40 Union St.

Slope Reconstruction

RE: Staff Review Comments for Preliminary Level I Site Alteration Plan

Subject: Comment Response – Back Cove Estates Slope Reconstruction – Level 1 Review.

**EXPLORATION LOCATION PLAN AND CONCEPTUAL SLOPE REPAIR**

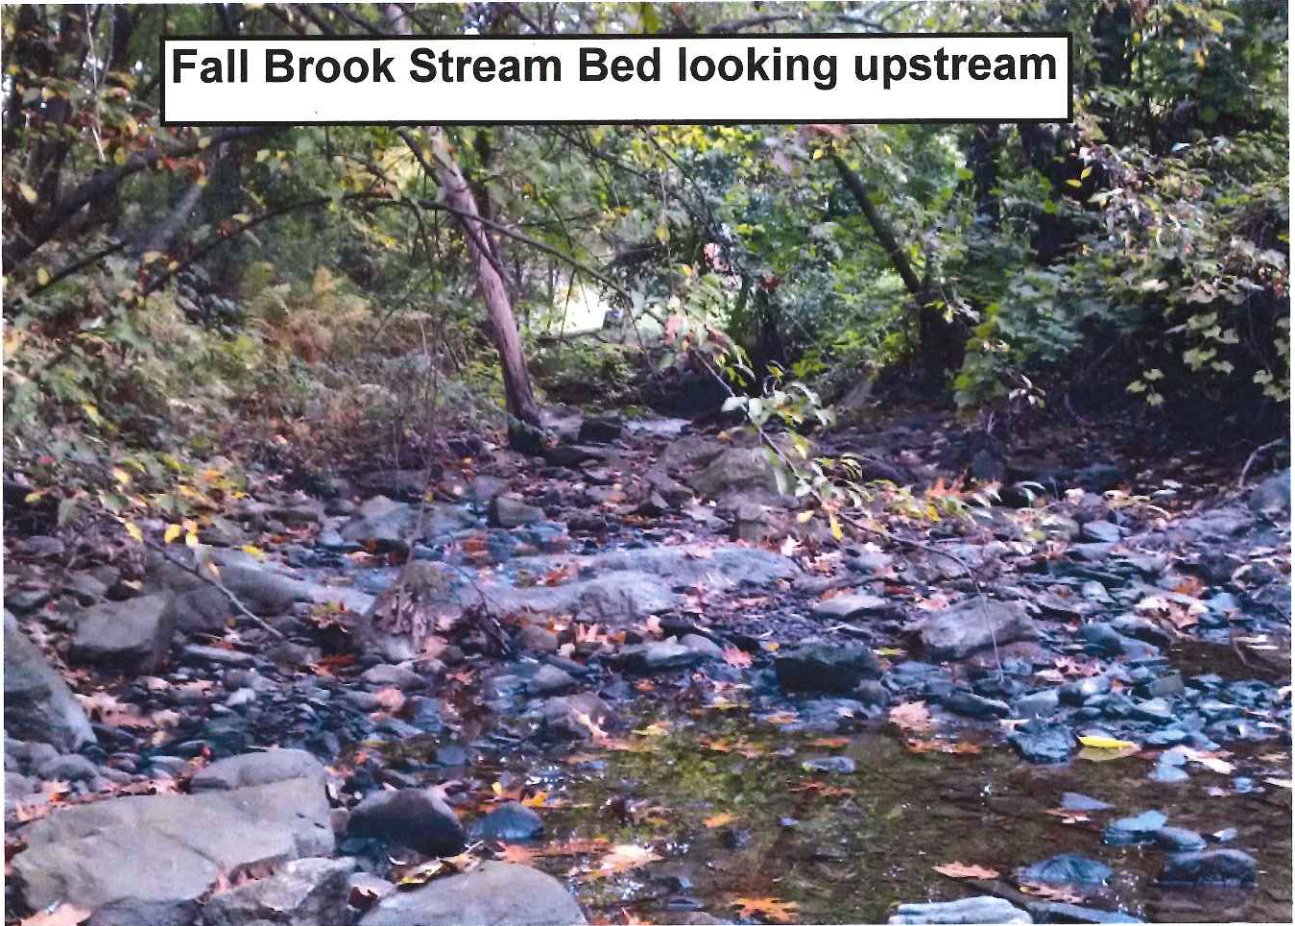
We recommend the slide area be repaired by armoring the stream bank with a boulder wall, removing the slide debris to expose undisturbed native clay and keying in a compacted granular borrow fill to re-establish the slope. The surface of the slope should be covered with a loam and seed that is protected by a turf reinforcement mat until a root mass of vegetation is established. We also recommend grading the slope and incorporating plantings to prevent future soil erosion. Conceptual Slope Repair details are illustrated on Sheet 1.

The conceptual slope repair details presented on Sheet 1 are provided for permitting purposes only and are not developed for bidding nor for construction. S.W. COLE ENGINEERING, INC should be engaged to help develop construction documents for slope repair, solicit and evaluate contractor proposals for slope repair and observe slope repair activities.
